**TO:** Wilton WPCA Commission  
**FROM:** Frank Smeriglio, PE, - Director of Public Works/Town Engineer *FS*  
**DATE:** September 9, 2022  
**RE:** 19 Cannon Rd

**GENERAL STATUTES § 7-246a APPLICATION OF  
BAYWING L.L.C. FOR SEWER EXTENSION,  
ALLOCATION OF  
SEWER CAPACITY, AND APPROVAL TO CONNECT A  
MULTI-FAMILY DEVELOPMENT  
AT 19 CANNON ROAD, WILTON**

**Wilton Water Pollution Control Authority**

**September 1, 2022**

**Sanitary Sewer  
Plan and Profile**

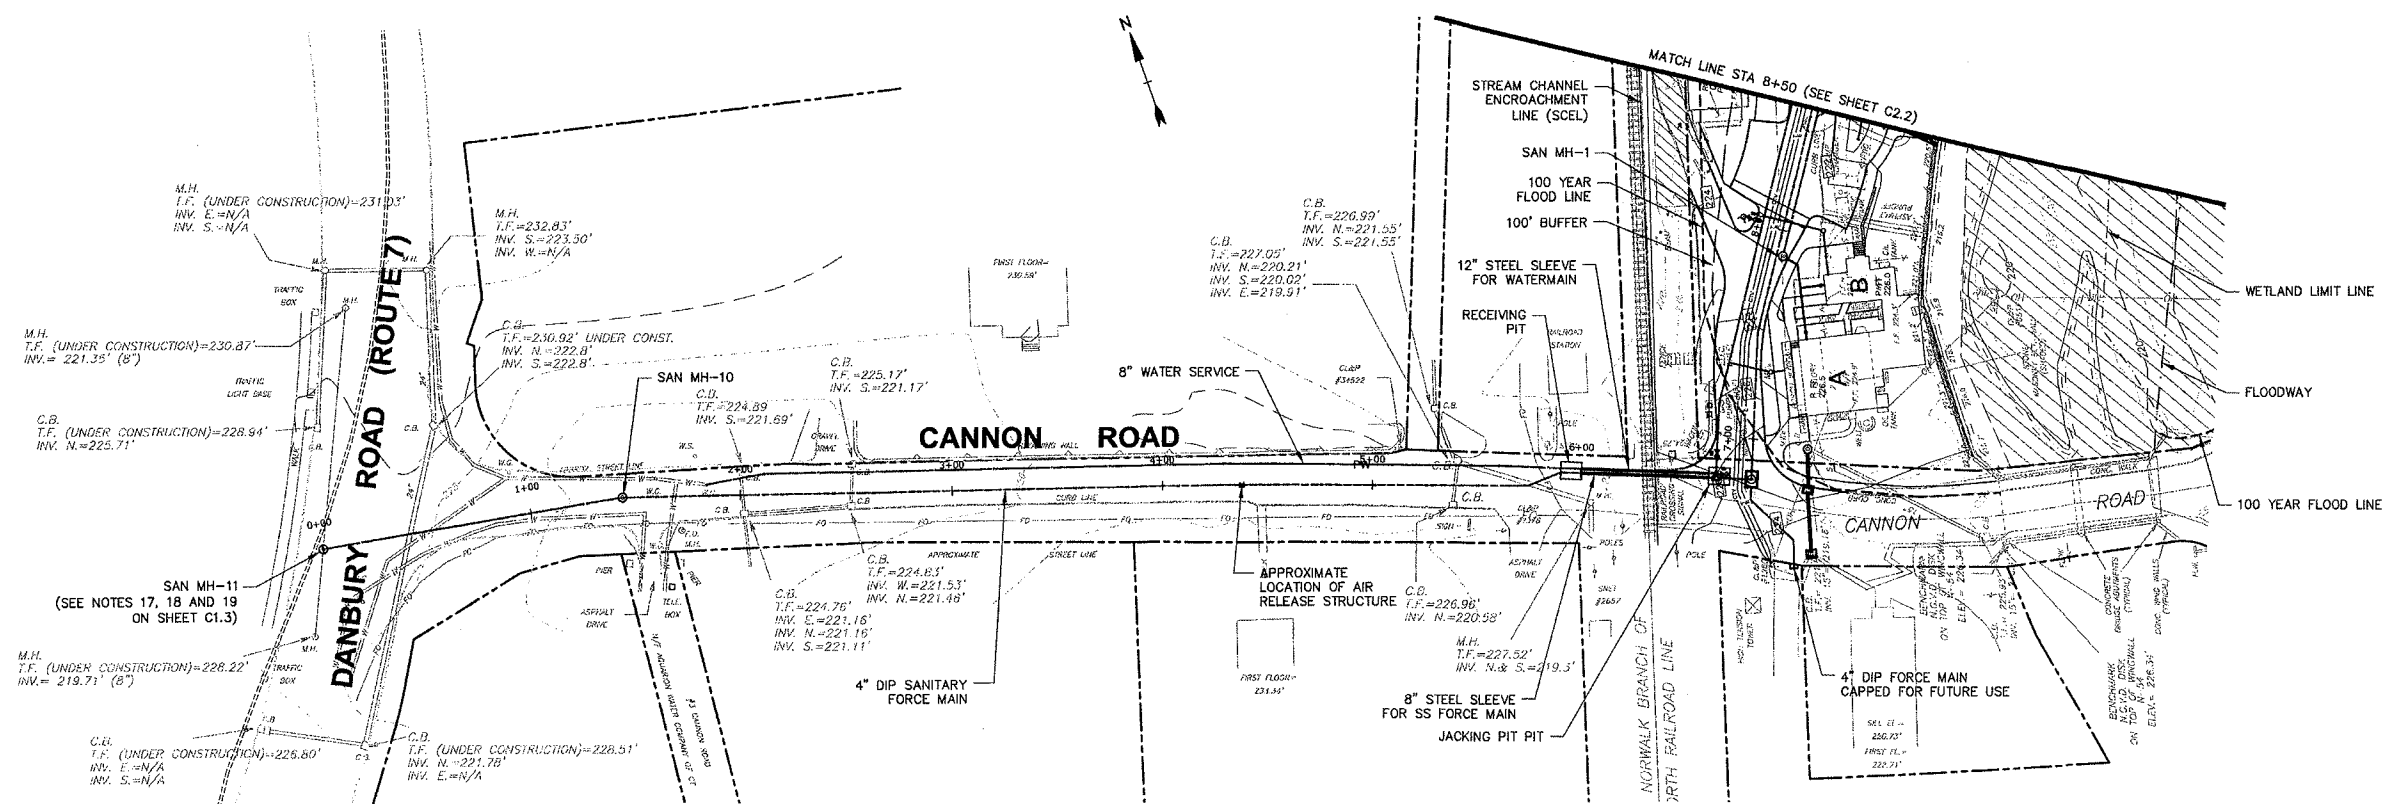
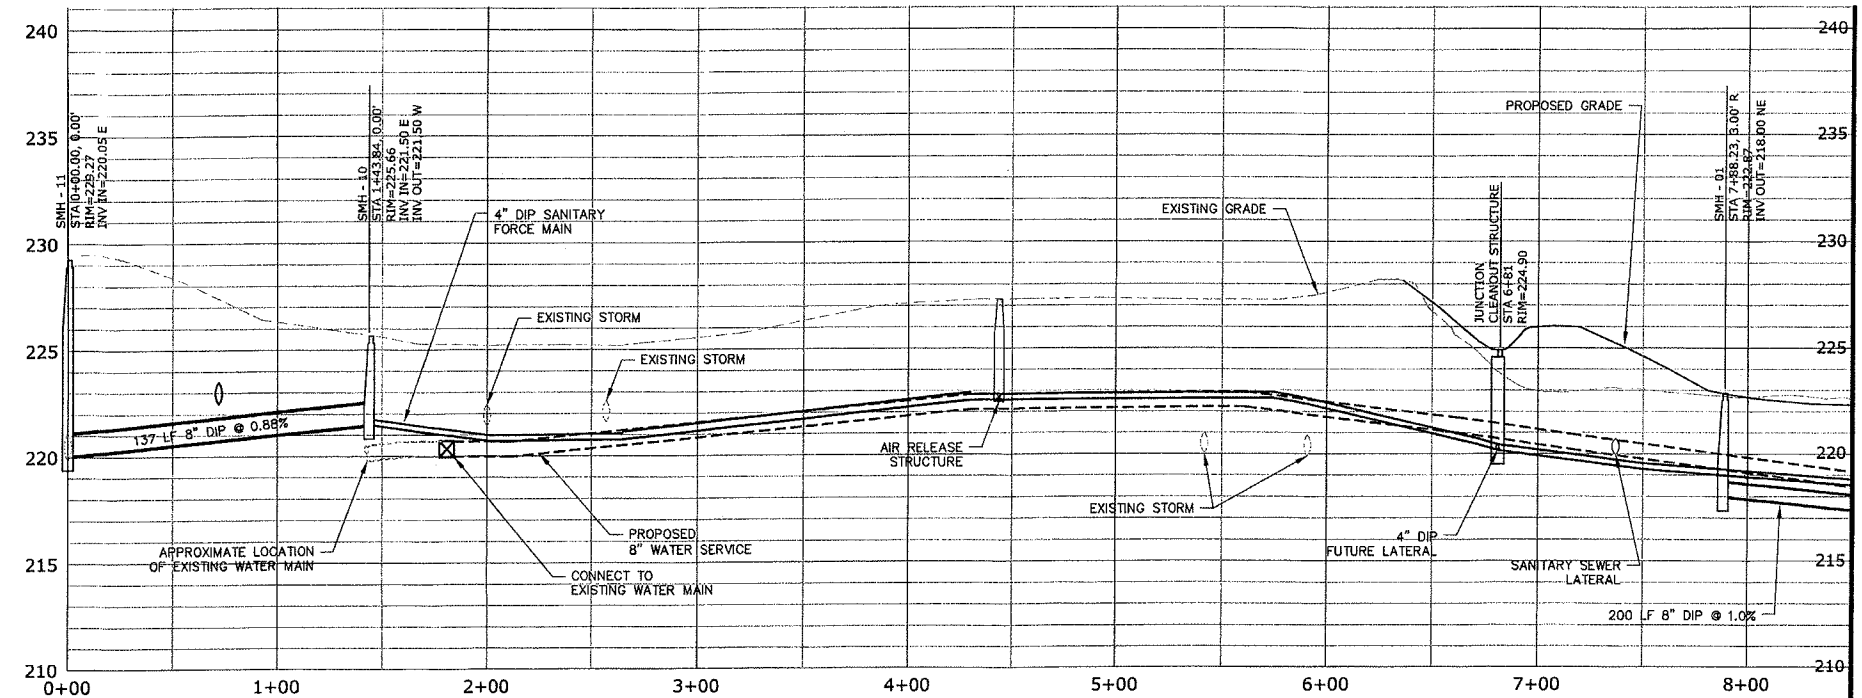
11. Need valves added at connections just east of RR, with MHs for access. Confirm that terminal cleanout structure will be large enough to fit assembly.

12. Add air release valve(s).

**RESPONSE:** A junction cleanout structure has been added just east of the railroad to accommodate the 4-inch valve for the Grange and the 4-inch valve for the proposed site. The terminal cleanout structure has been eliminated in favor of the junction cleanout structure and it will be adequate to accommodate the required fittings and appurtenances proposed.

**RESPONSE:** We have added two air release valves to the plan sheets. The first valve is located in the valve vault, and the second is located approximately at station 4+30.

**TYPICAL PUMP STATION DETAIL**  
NO SCALE

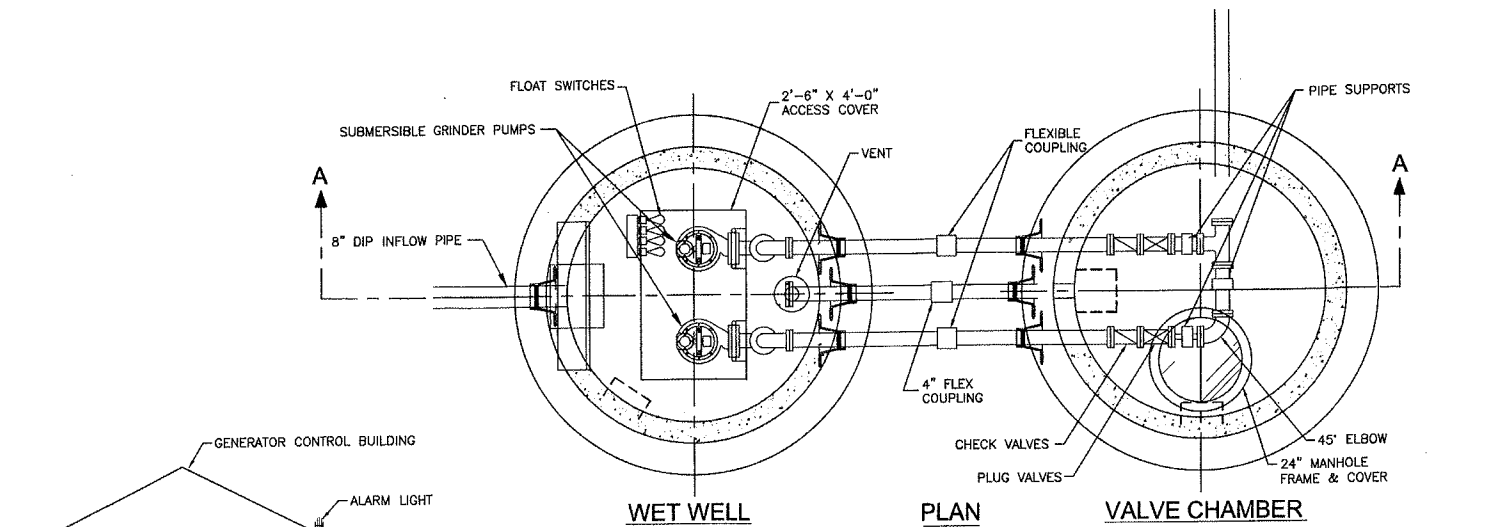
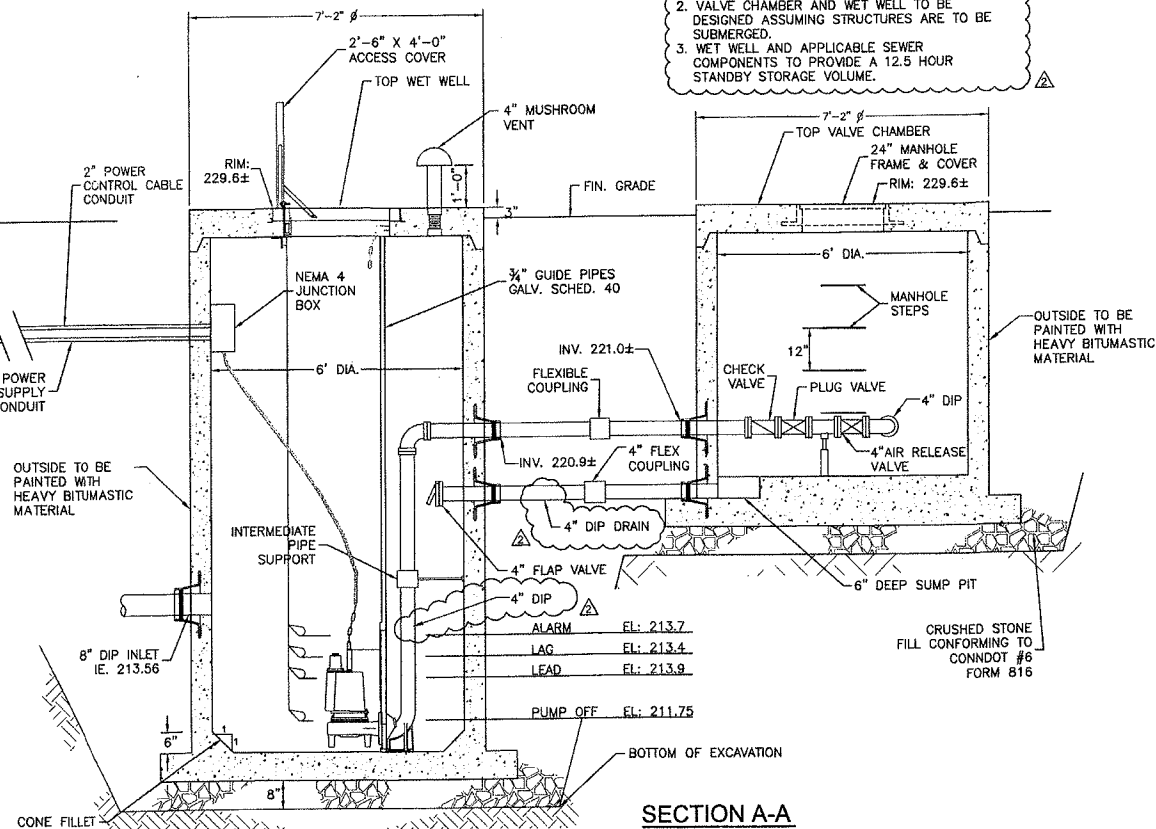
3. *Revise Plans to show watertight manhole covers and hatches.*

4. *Revise plans to show waterproof wet well structures and connections.*

4. *Please identify discharge pipe size and material inside the wet well on drawing number C-4.4.*

**RESPONSE: We have revised the detail sheet to incorporate this comment.**

**RESPONSE: We have revised the detail sheet to incorporate this comment.**

**RESPONSE: We have revised the detail sheet to incorporate this comment.**

**JUNCTION CLEANOUT STRUCTURE**  
NO SCALE

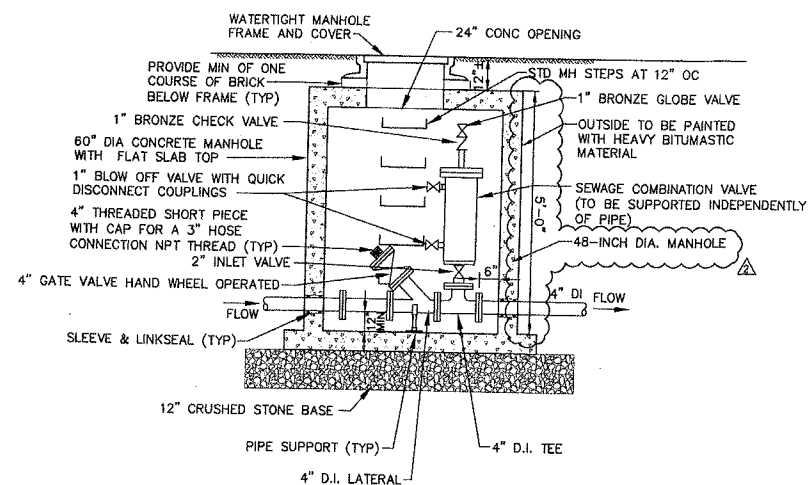
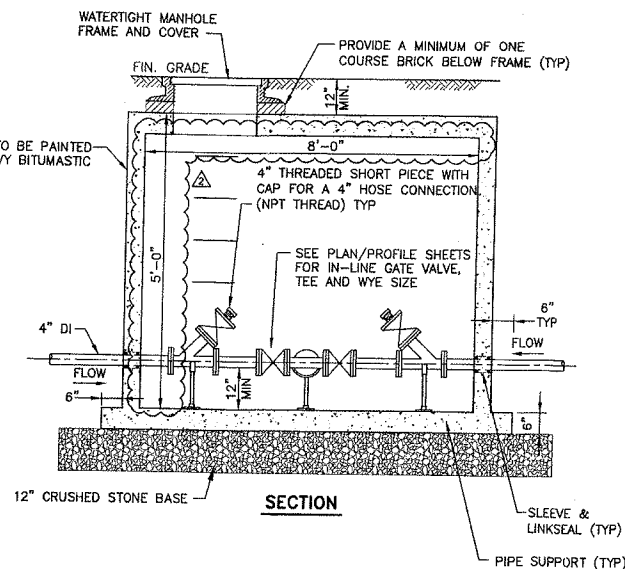
5. *Add overall dimensions to junction cleanout and air release structure details on drawing number C-4.5.*

**RESPONSE: We have revised the detail sheet to incorporate this comment.**
